**Section 16 Planning Application for Proposed Minor Relaxation of  
Building Height and Plot Ratio Restrictions  
for Permitted Public Housing Development at  
Long Bin, Yuen Long  
(Application no. A/YL-TYST/1285)**

**S.16 Application No. A/YL-TYST/1285**

**Responses to Comments**

PRELIMINARY

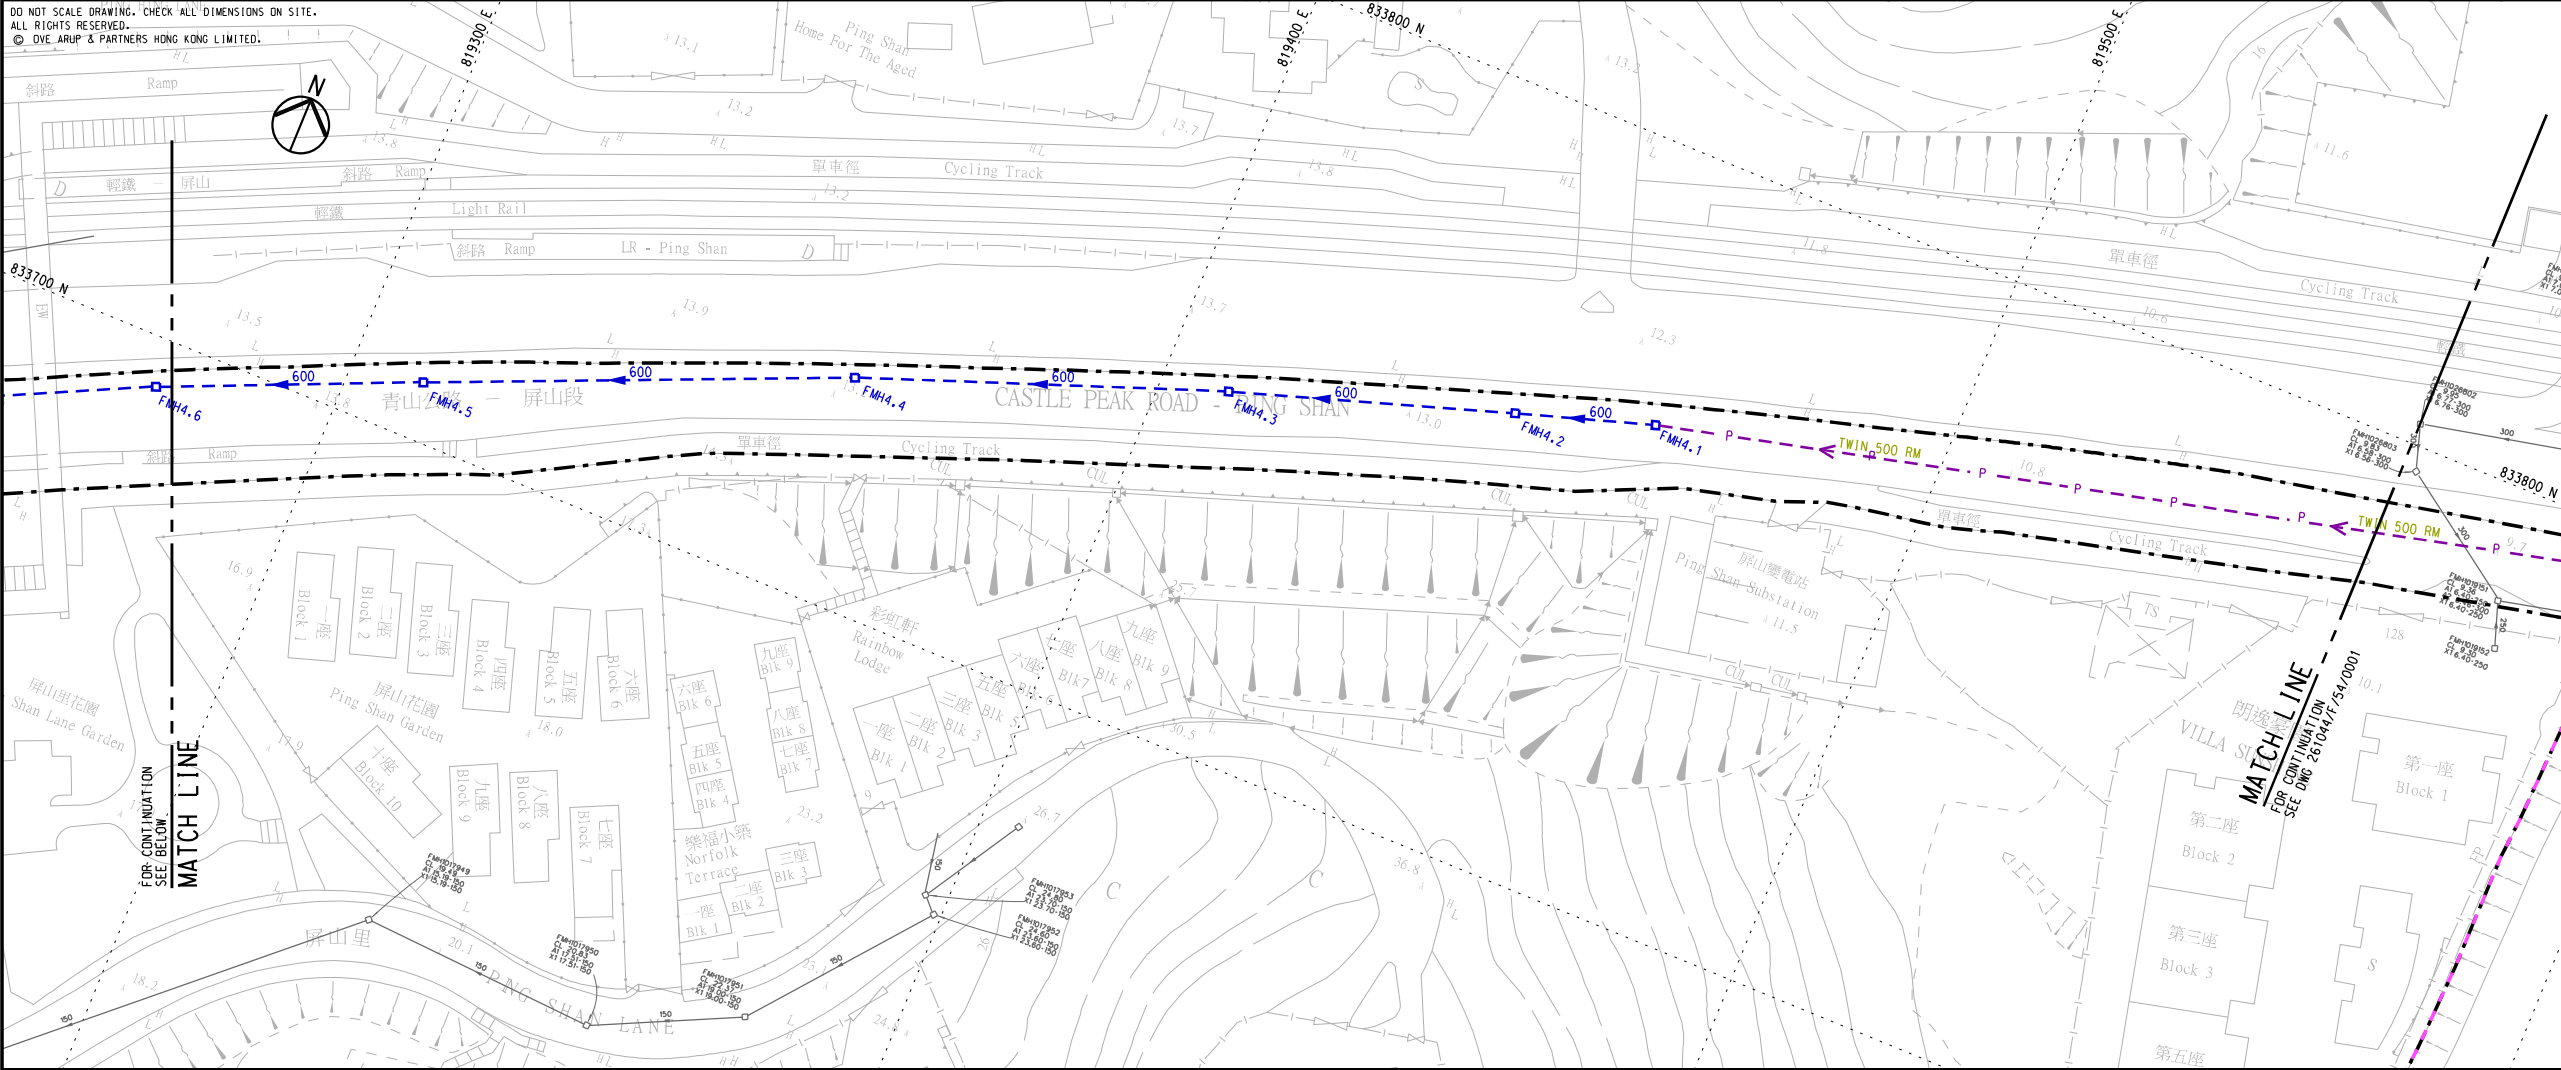
3. Figure 2: please show the proposed sewer in the layout plan.	Please refer to <b>Attachment 3</b> for the plans showing the proposed sewers (as extracted from the approved SIA study of CE 75/2017 (CE)).
